## HISTORIC AND DESIGN REVIEW COMMISSION

### Agenda Item No: 21

**HDRC CASE NO:** 2016-203  
**ADDRESS:** 431 ADAMS ST  
**LEGAL DESCRIPTION:** NCB 2880 BLK 5 LOT 9  
**ZONING:** RM4 H  
**CITY COUNCIL DIST.:** 1  
**DISTRICT:** King William Historic District  
**APPLICANT:** Jorge Araujo  
**OWNER:** Scott & Hoda Cummings, Scott & Hoda Cummings  
**TYPE OF WORK:** Demolition of accessory structure and new construction  
**REQUEST:**

SHEET  
A1

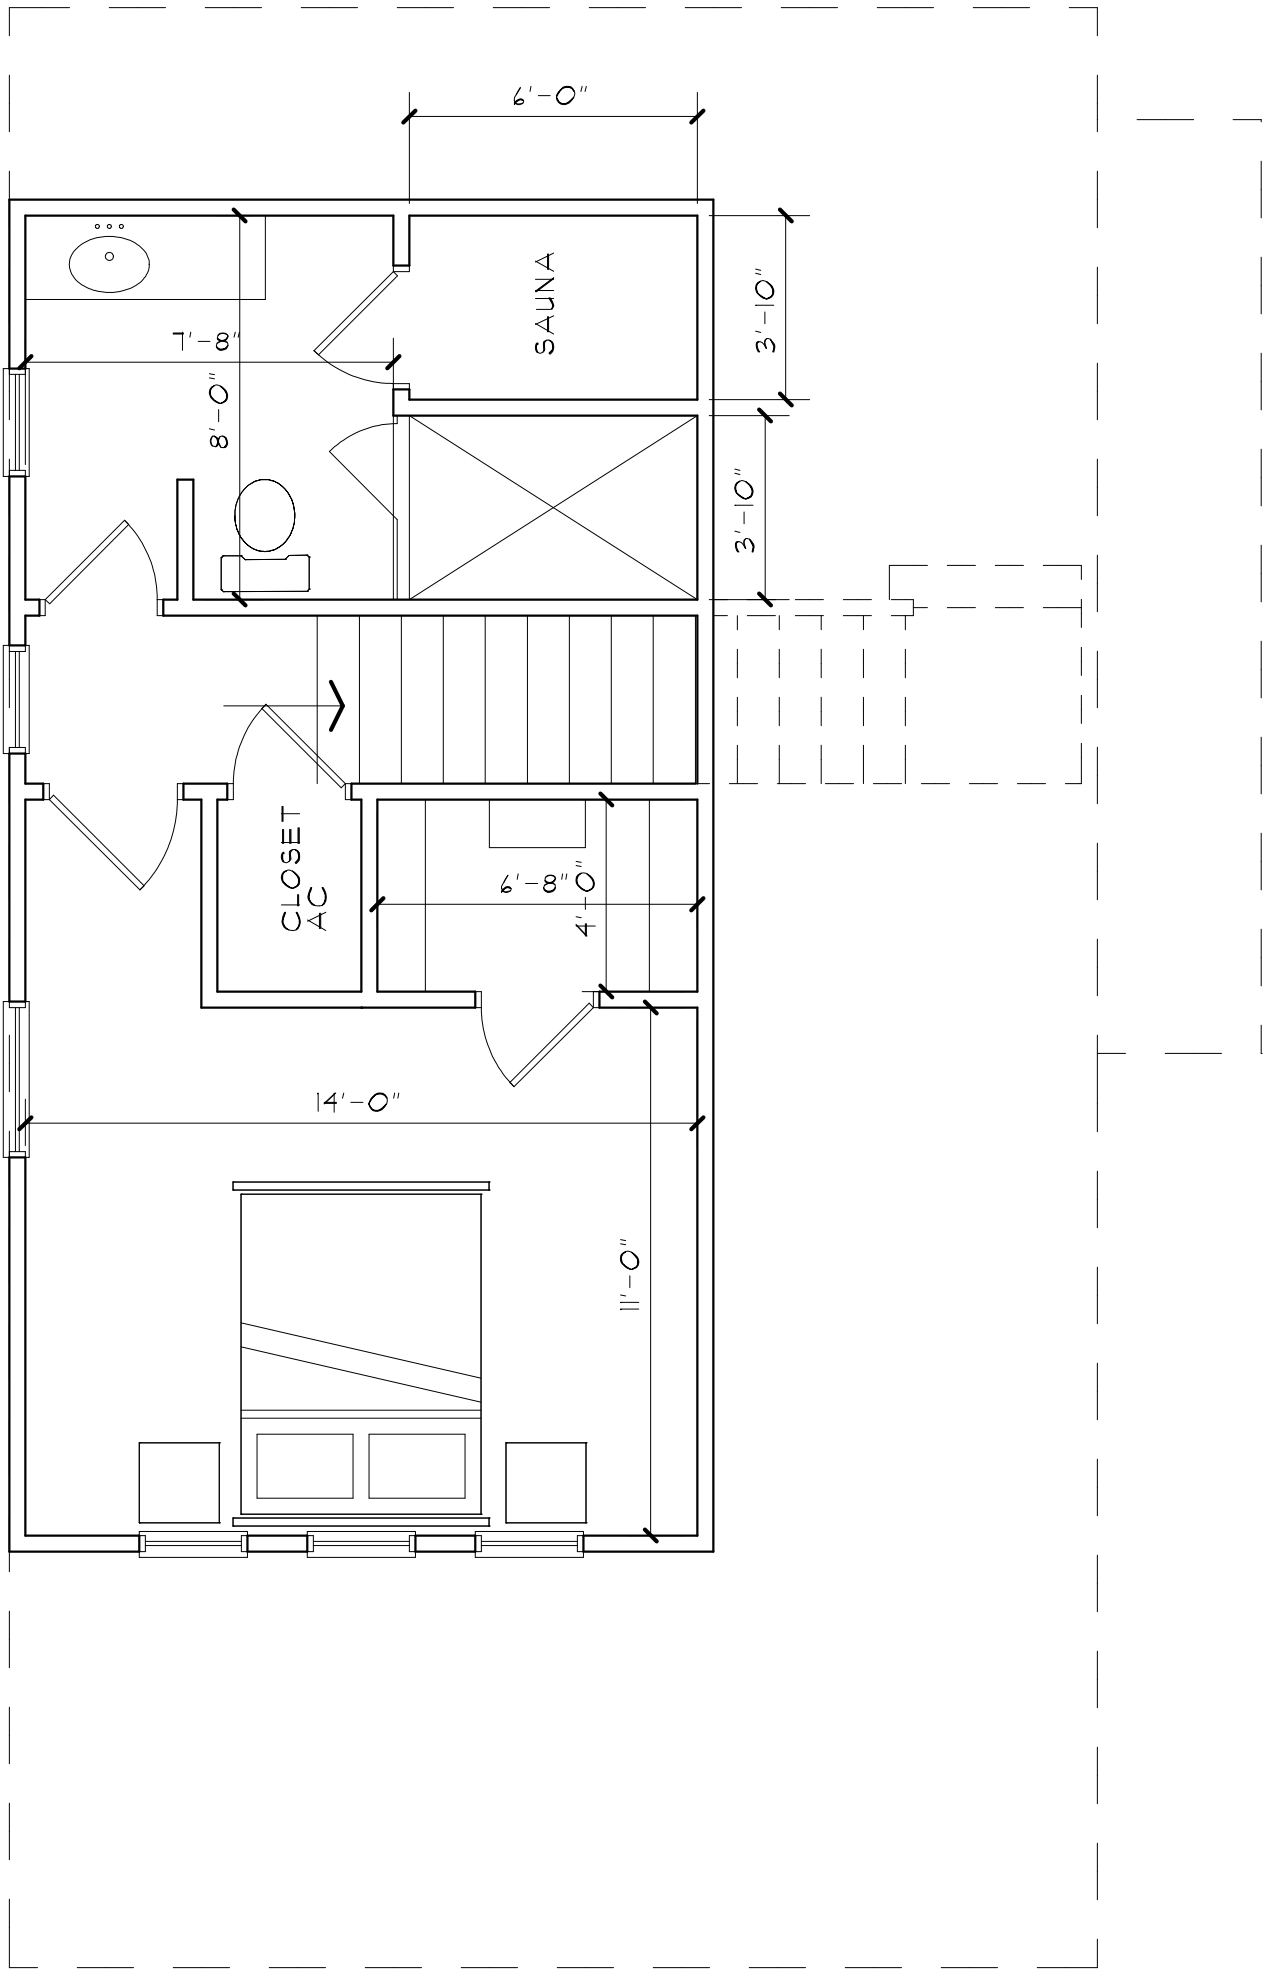
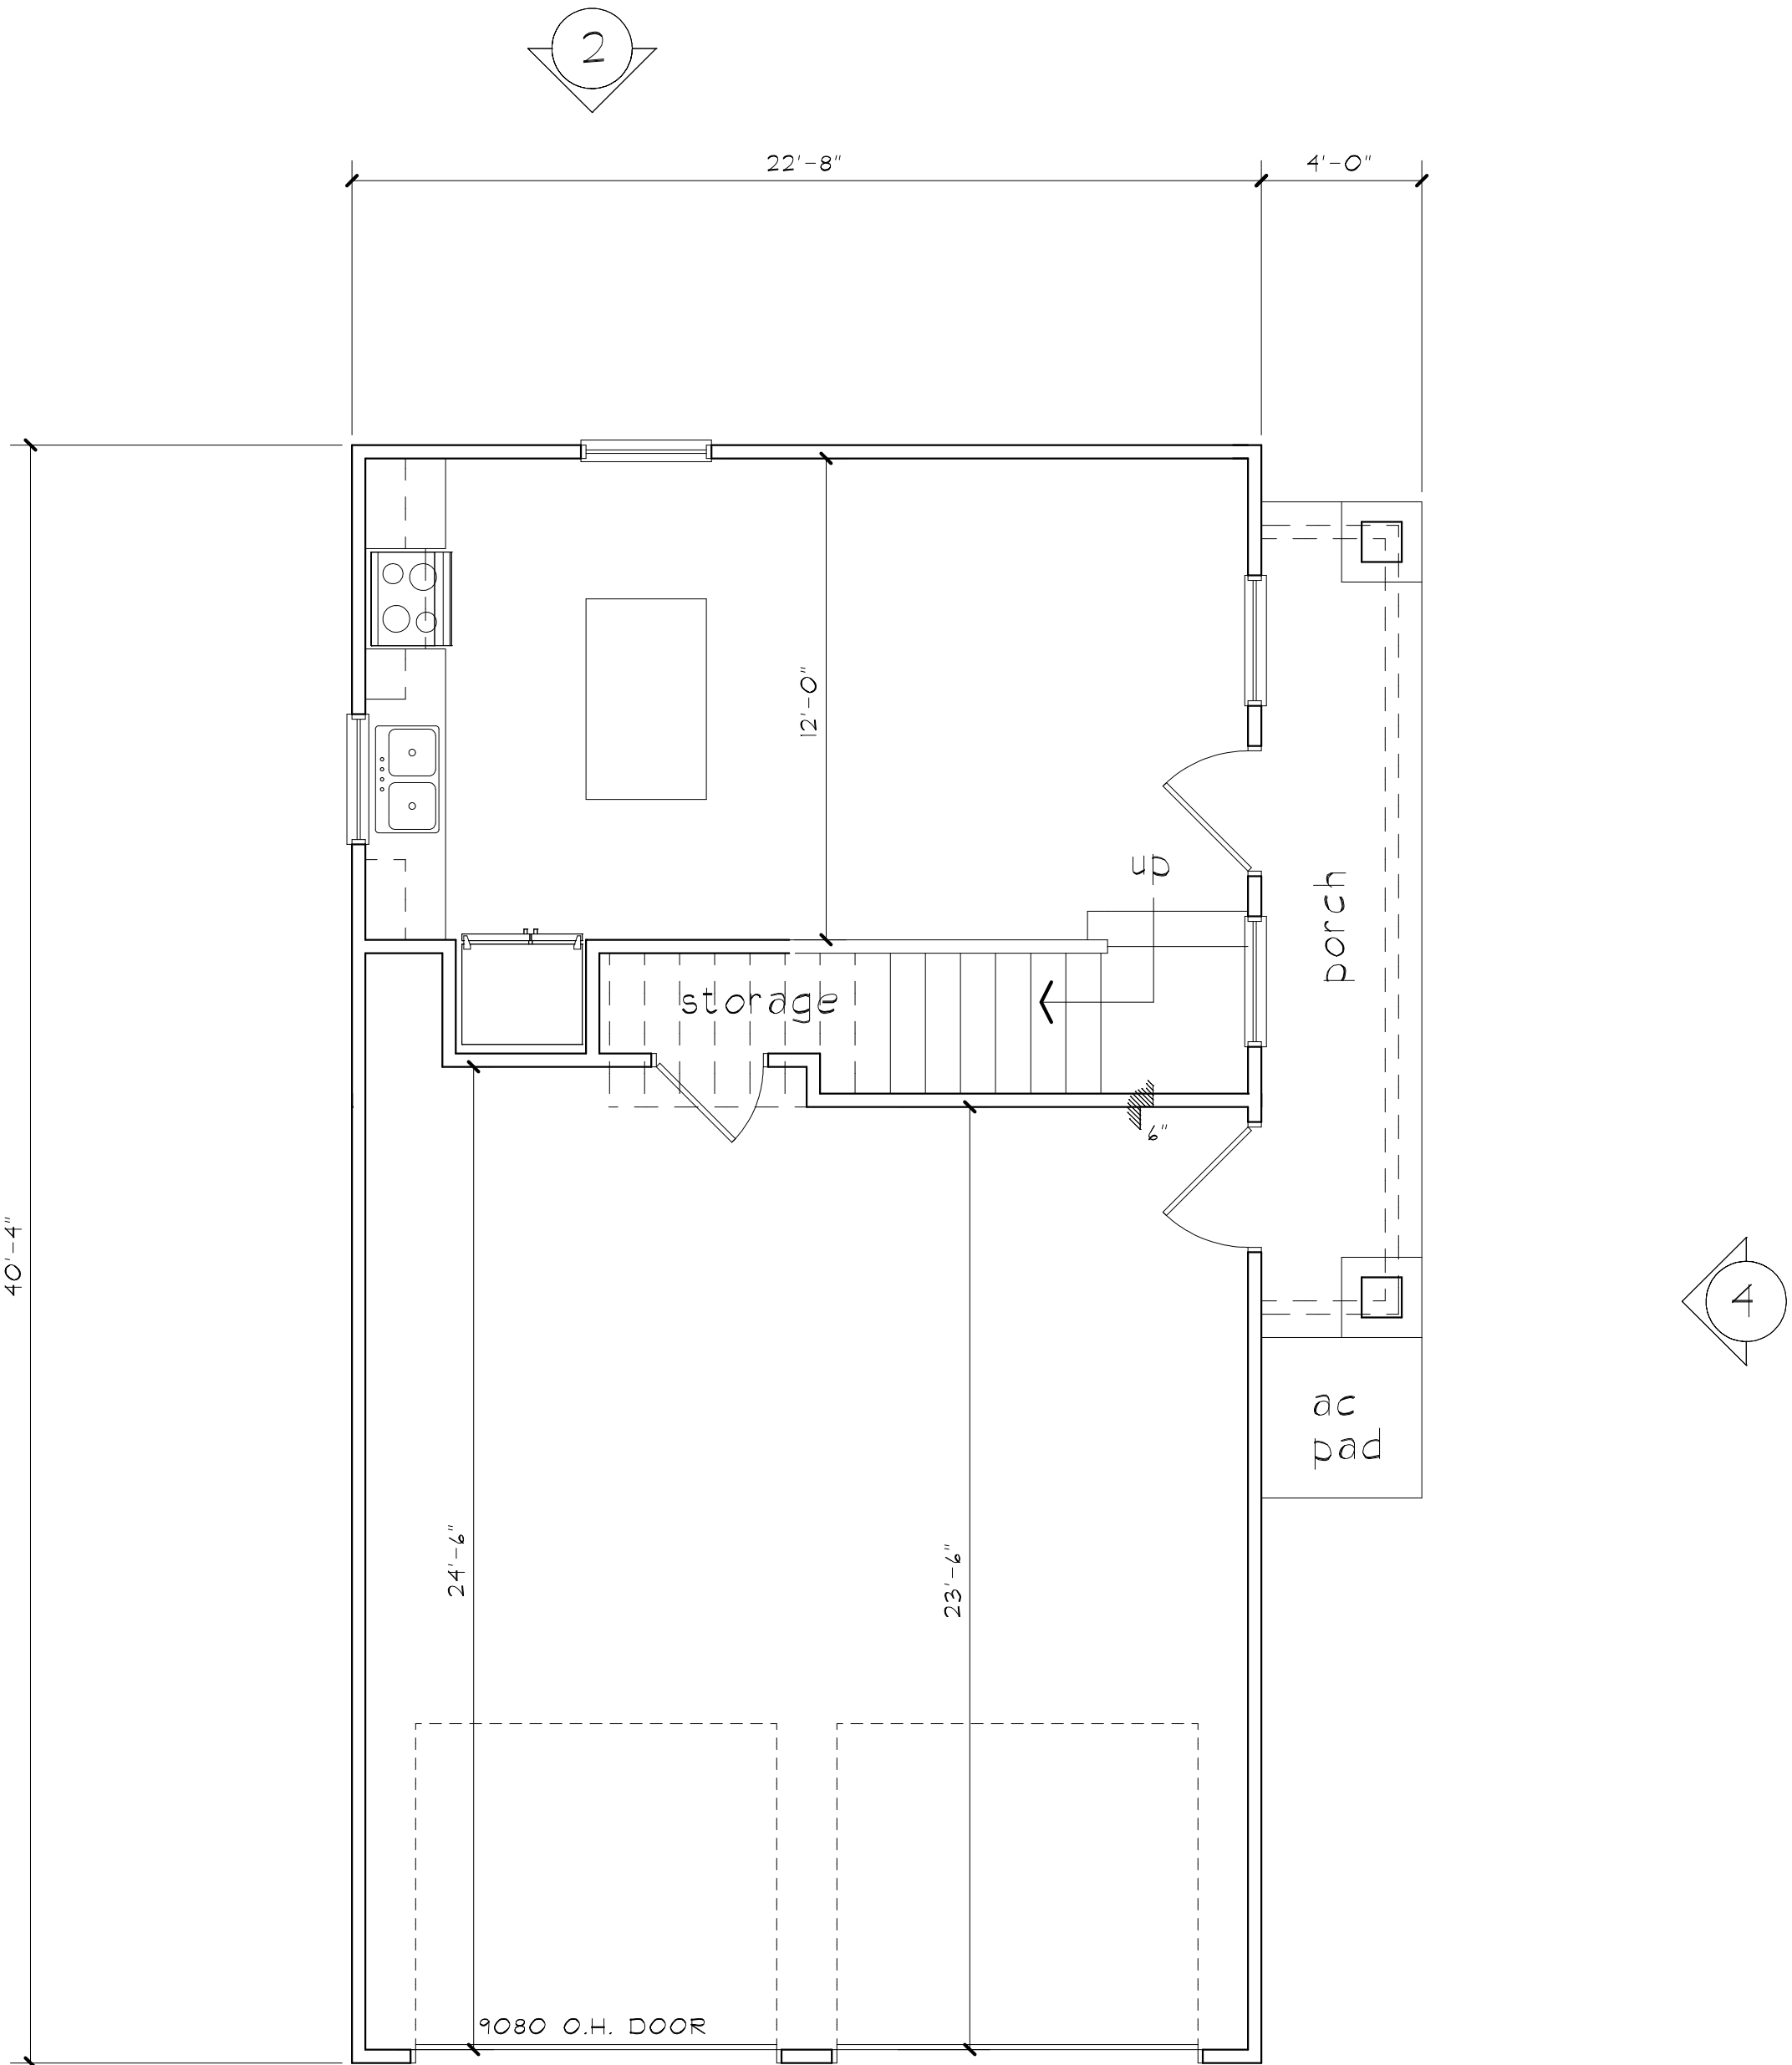
- d. **BUILDING SIZE** – The applicant has proposed an overall building size of approximately 1,000 square feet. The primary historic structure features a footprint of approximately 1,500 square feet. The applicant's proposed building size is neither appropriate for the lot at 431 Adams nor is it consistent with the Guidelines for New Construction. Staff recommends that the applicant reduce the overall footprint of the proposed structure to less than forty (40) percent of the primary historic structure's footprint.

- g. **WINDOWS & DOORS** – The applicant has noted that the accessory structure is to feature aluminum windows that are to match the profile of the windows found in the primary historic structure. Staff finds that wood windows would be more appropriate. Each window should be inset within walls at least (2) inches. In regards to window placement, the applicant has proposed for the accessory structure to include walls that at times are void of fenestration of façade separation. This is neither appropriate nor consistent with the Guidelines. Staff recommends the applicant propose fenestration patterns that provide façade separation and negate long expanses of blank walls.

1. That the applicant reduce the proposed massing and footprint of the proposed accessory structure to be more appropriate for the primary historic structure.
2. That the address the architectural inconsistencies including siding orientation and the proposed garage doors.
3. That the applicant provide information in regards to the proposed windows including their installation.

4. That the applicant introduce additional windows or make other design changes to reduce the overall lack of fenestration.
